N5225A-02A

S E R V I C E N O T E

N5225A PNA Series Microwave Network Analyzers

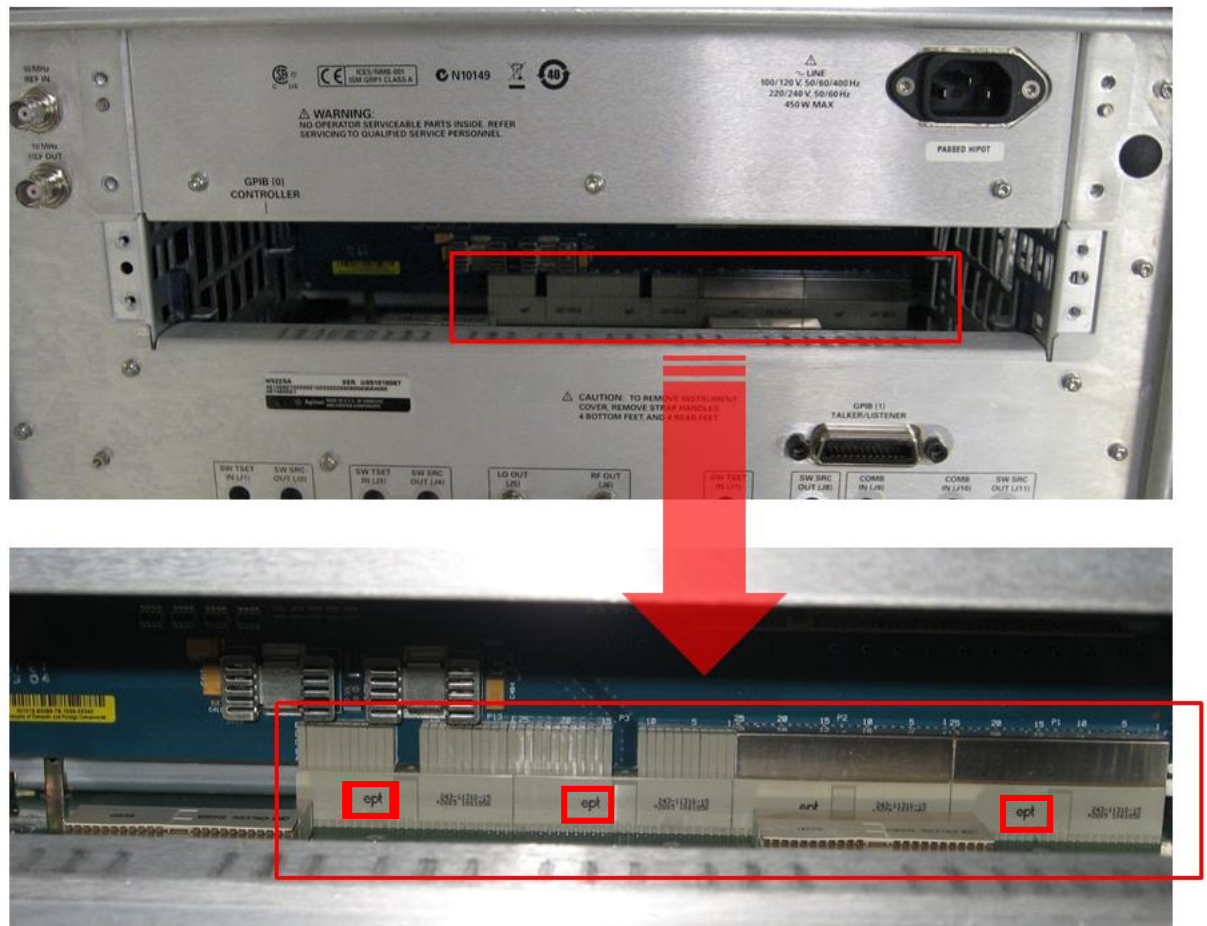
1. Remove the CPU assembly from the analyzer's rear panel. Refer to the PNA Service Guide chapter 7 section titled, "Removing and Replacing the CPU Board Assembly" for removal and reinstallation procedures. To view the online Service Guide, see the numbered list on the next page for instructions.
2. As per the photo below, inspect the system motherboard connector to see if it has one or more "ept" logos.

3. If the connector has one or more “ept” logos, return the analyzer to Agilent for replacement of the system motherboard. If the connector does not have one or more “ept” logos, email ctd-soco_support@agilent.com, providing the analyzer model and serial number and details of the malfunction symptoms.
